Item ID: D350-689-031 Accept *N900040100* Setup Start *NS1*
 Revision ID: Stop *NS2*
 Item Name: Armrest/Control Guard
 Start Date: 7/10/12 Start Qty: 1.00 *1* Cust Item ID:
 Required Date: 8/17/12 Req'd Qty: 1.00 *1* Customer:
 Reference:

DART SERVICE INSTRUCTION

TO AMEND INSTALLATION INSTRUCTIONS IIN-D350-689 REV. B

TO PROVIDE CUSTOMERS WHO HAVE PURCHASED D350-689-011/-021 DUAL HIGH BACK SEAT KITS WITH AN OPTIONAL D350-689-031 ARMREST/CONTROL GUARD KIT.

FIGURE 1: Removal of D350-689-019 Control Guard Kit

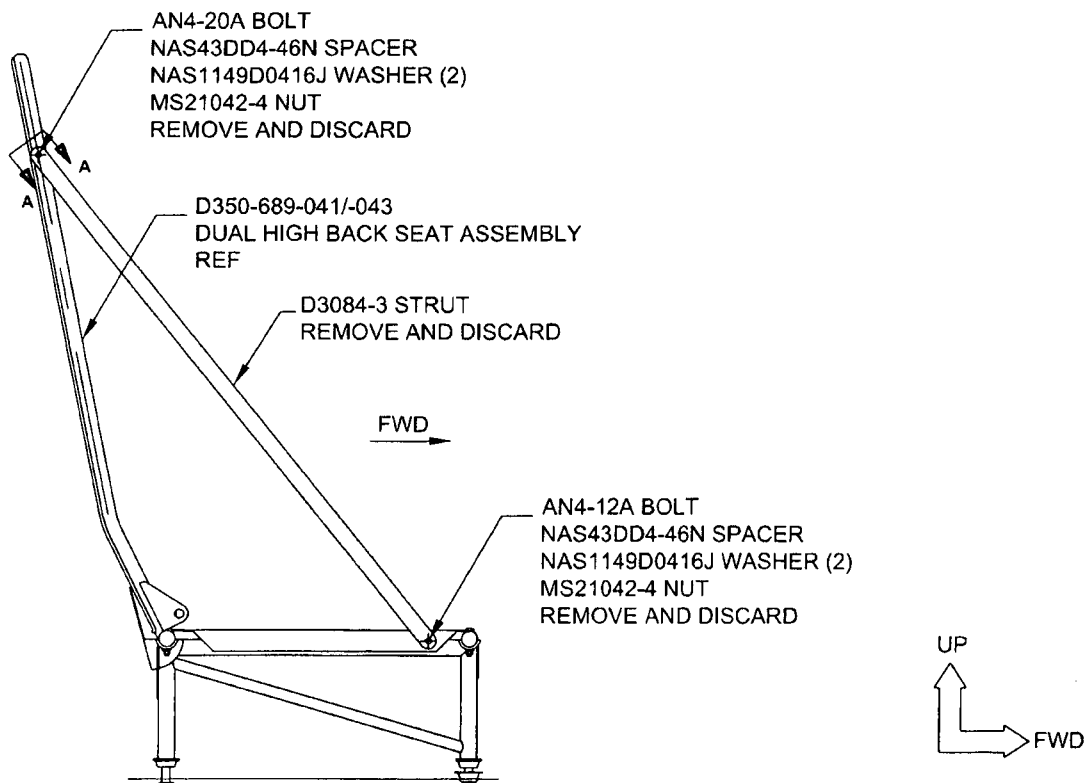
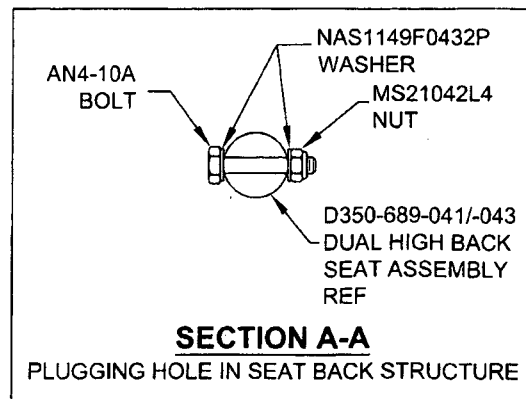
THE D350-689-031 ARMREST/CONTROL GUARD KIT REPLACES THE D350-689-019 CONTROL GUARD KIT, WHICH WAS FOUND TO BE INEFFECTIVE.

- 2) REMOVE THE D350-689-041/-043 SEAT IN ACCORDANCE WITH ICA-D350-689, SECTION 25.2 / 25.4.
- 3) FOR CUSTOMERS EQUIPPED WITH THE D350-689-019 CONTROL GUARD KIT, REMOVE AND DISCARD THE KIT. PLUG THE HOLE IN THE SEAT BACK STRUCTURE USING THE (1X) AN4-10A BOLT, (2X) NAS1149D0432J WASHERS AND (1X) MS21042L4 NUT PROVIDED IN THE D350-689-031 KIT AS SHOWN IN FIGURE 1.

FIGURE 2: D350-689-031 ARMREST/CONTROL GUARD KIT

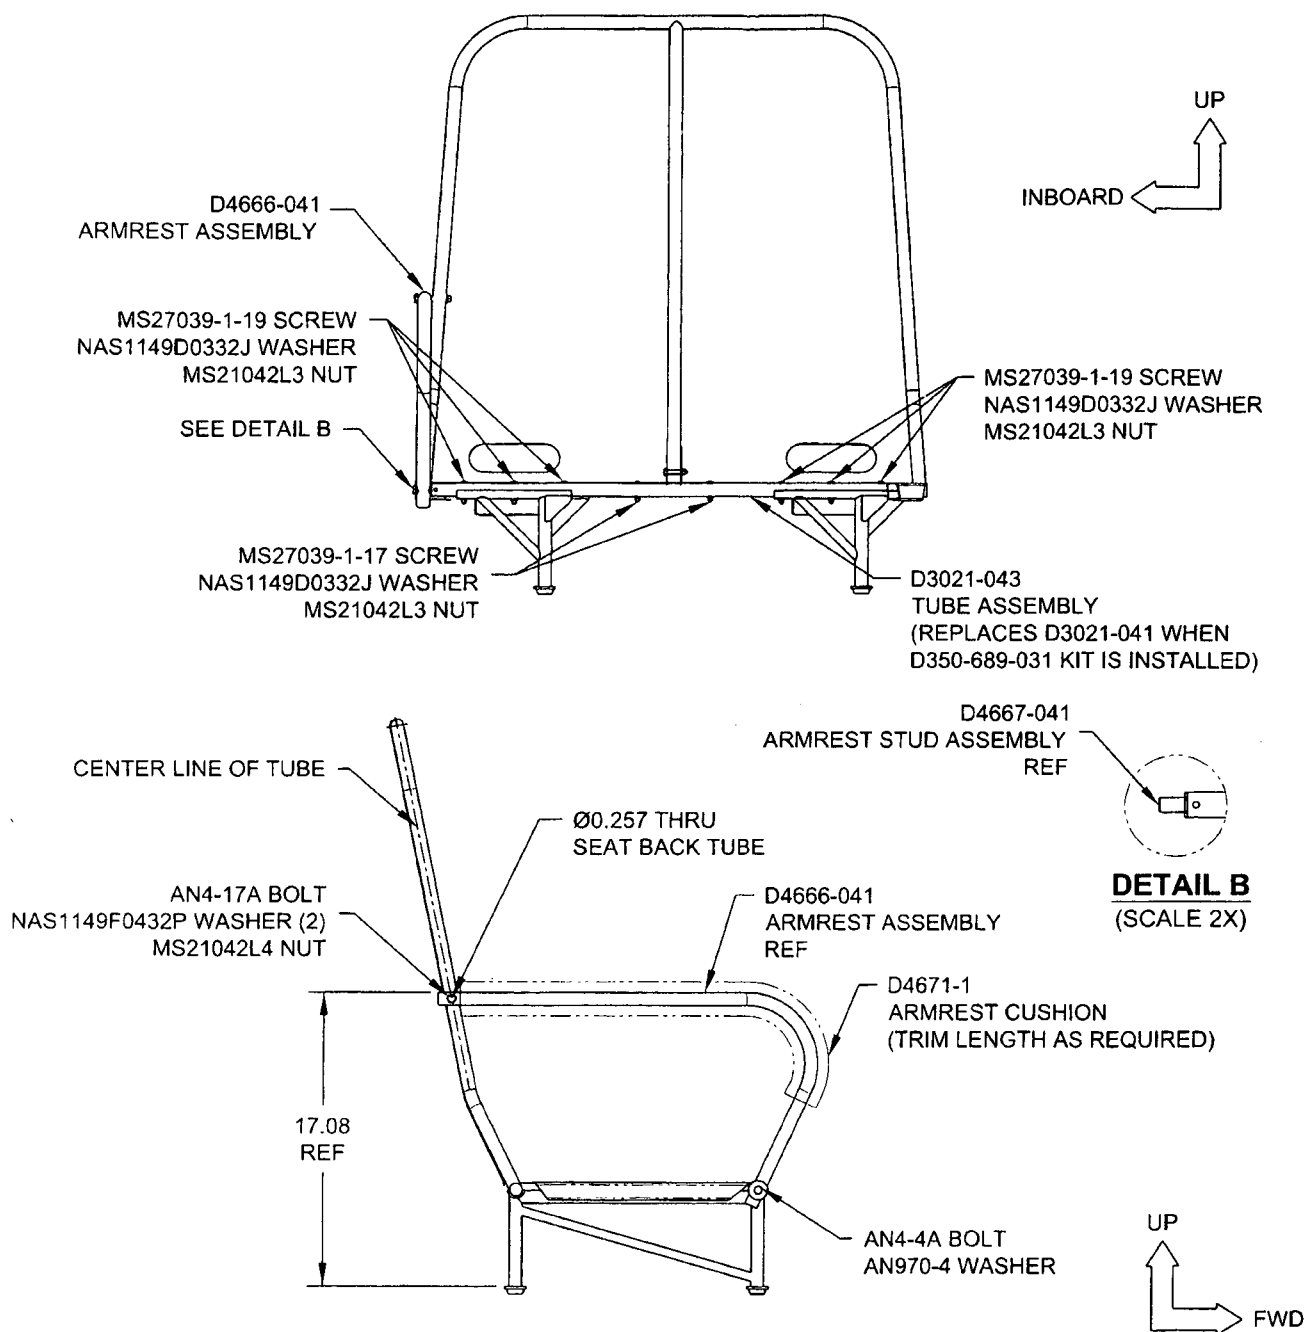
- 4) REMOVE THE D3021-041 TUBE ASSEMBLY FROM THE SEAT BASE STRUCTURE, BY UNFASTENING THE (6X) MS27039-1-19, (2X) MS27039-1-17 SCREWS, (8X) NAS1149D0332J WASHERS AND (8X) MS21042L3 NUTS AS SHOWN IN FIGURE 2. RETAIN THE HARDWARE IF SERVICEABLE.

- 5) REFERRING TO FIGURE 2: REPLACE THE D3021-041 TUBE ASSEMBLY WITH THE D3021-043 TUBE ASSEMBLY ENSURING THAT THE END WITH THE D4667-041 STUD ASSEMBLY FACES INBOARD. REINSTALL THE (6X) MS27039-1-19, (2X) MS27039-1-17 SCREWS, (8X) NAS1149D0332J WASHERS AND (8X) MS21042L3 NUTS. TORQUE FASTENERS TO 20-25 in-lb (2.3-2.8 Nm).

- 6) REFERRING TO FIGURE 2: INSTALL THE D4666-041 ARMREST ASSEMBLY ONTO THE SEAT BASE USING (1X) AN4-4A BOLT AND (1X) AN970-4 WASHER. INSTALL FINGER TIGHT. DO NOT TORQUE AT THIS TIME.

ROTATE THE D4666-041 ARMREST ASSY UNTIL THE HOLE AT THE AFT END OF THE TUBE ALIGNS WITH THE CENTER LINE OF SEAT BACK TUBULAR STRUCTURE . USING THE HOLE IN THE ARMREST AS A GUIDE DRILL Ø0.257 THRU THE SEAT BACK STRUCTURE.

INSTALL (1X) AN4-17A BOLT WITH (2X) NAS1149F0432P WASHER AND (1X) MS21042L4 NUT.

TORQUE AN4 BOLTS TO 50-70 in-lb (5.6-7.9 Nm).
